MANDATORY**MEL-24-04****TITLE**

ELECTRICAL POWER - TRANSMITTAL OF CONTINENTAL AEROSPACE TECHNOLOGIES CRITICAL SERVICE BULLETIN CSB19-06

ALERT SERVICE BULLETIN No. 081 Rev. A

Alternator Castellated Hex-Nut Inspection

Figure 1 - Alternator, Typical - Continental Aerospace Technologies

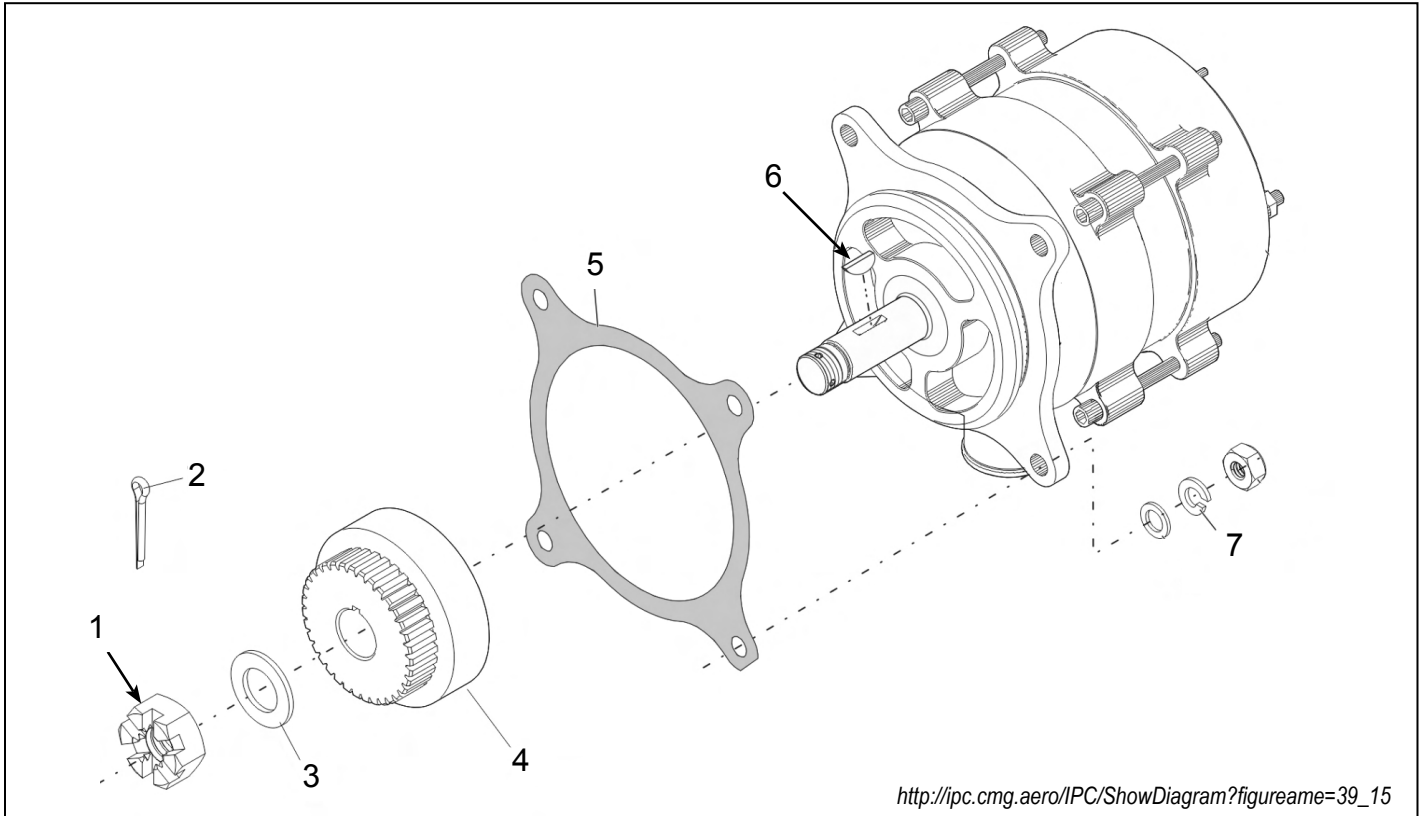
- (1) Alternators listed in section 1.A could contain a castellated hex-nut (1, Figure 1) that does not torque flush with the thrust washer (3). This condition could compromise the integrity of the drive coupling retention system.
 - (a) Loss of drive coupling retention may result in engine damage and/or unexpected loss of engine power.
- (2) This ASB is to advise the field of a known condition and to supply inspection criteria to identify affected alternators.

- (5) Remove and discard from alternator; cotter pin (2), castellated hex-nut (1), thrust washer (3), and woodruff key (6). Refer to Figure 1.
- (6) Inspect drive coupling (4) in accordance with applicable service instructions.
- (7) Install new replacement components not affected by this ASB onto the alternator in accordance with applicable engine manufacturer's maintenance manual. Refer to Table 1 - Materials Required.

4. This revision is issued to change the following:
 - A. Correct part number typo, Table 1, Materials Required:
 - (1) Change thrust washer P/N 63097 to 63091 (Table 1, ITM# 3).

Figure 4 - Roll-Stamped "AD"

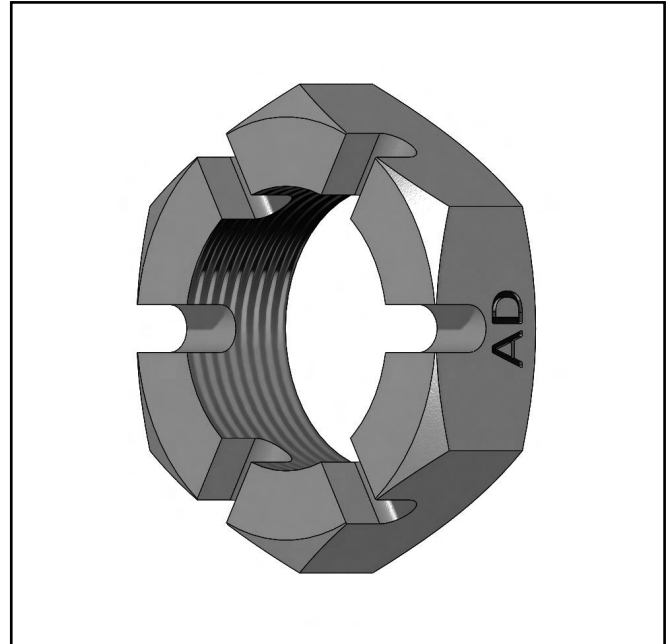
- B. Revise 3.B.2.(c) to reflect change to Figure 4:
 - (1) Change to: Hex-nut (1) is roll-stamped with the letters "**AD**".
 - C. Add task 3.B.(6) for clarification:

- (1) Inspect drive coupling (4) in accordance with applicable service instructions.
 - D. Change Figure 4 from Machined Groove to Roll-Stamped "**AD**" and update illustration.

Figure 5 - Center-Punch Mark

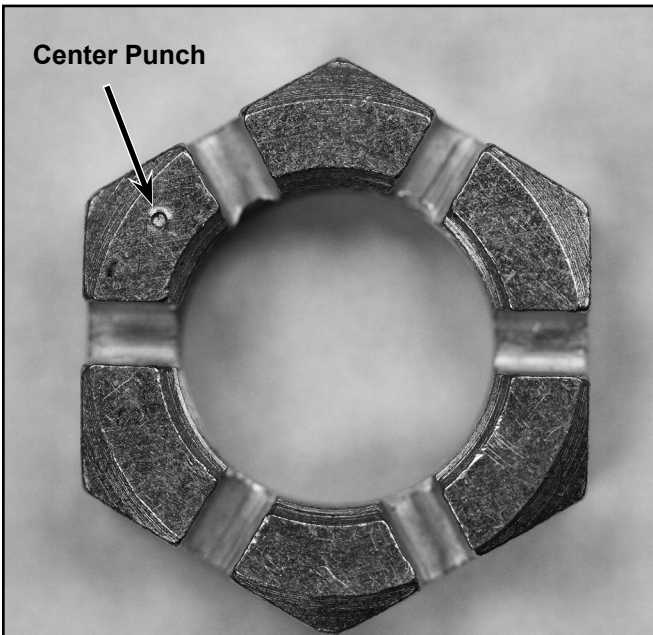
- (a) If the measurement at any nut flat is \geq .002 in. (.0508 mm), continue to 3.B.(5).
- (b) If the measurement at each nut flat is $<$.002 in. (.0508 mm), no corrective action is required.
 - 1) Using an automatic center punch, punch the face of the hex-nut (1) so that it will be easily identified for future reference (Refer to Figure 5). Continue to 3.B.(8).

Figure 6 - Gap Measurement

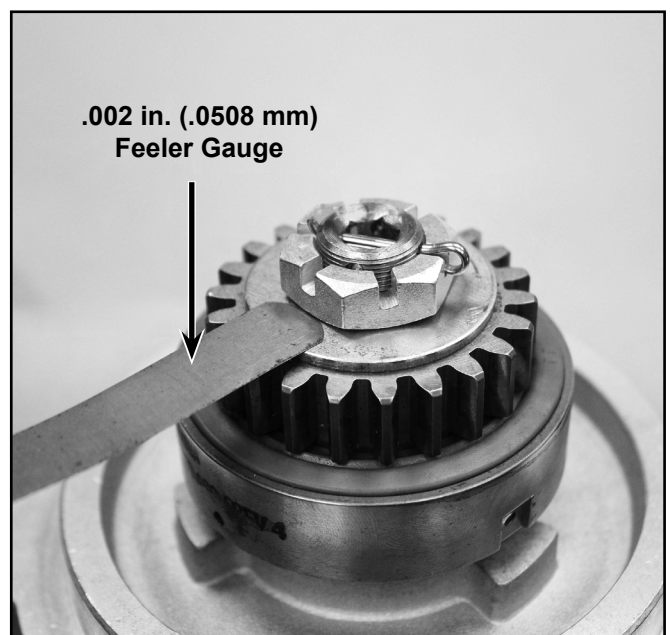
- (1) Remove the alternator from the engine in accordance with the latest revision of the aircraft and/or engine manufacturer's maintenance manual.
- (2) Inspect castellated hex-nut (1). If one the following indicators is present, the alternator is in compliance with this ASB. Refer to Figures 3 thru 5.
 - (a) Hex-nut (1) is laser etched with the letter "H";
 - (b) Hex-nut (1) is stamped with a center-punch;
 - (c) Hex-nut (1) is roll-stamped with the letters "AD".
- (3) If any indicator stated above **is not** present, proceed to 3.B.(4). If one of the indicators stated above **is** present, continue to 3.B.(8).
- (4) Using a .002 in. (.0508 mm) feeler-gauge, measure the gap between the nut thrust face and the thrust washer at each of the six hex-nut flats. Refer to Figure 6.
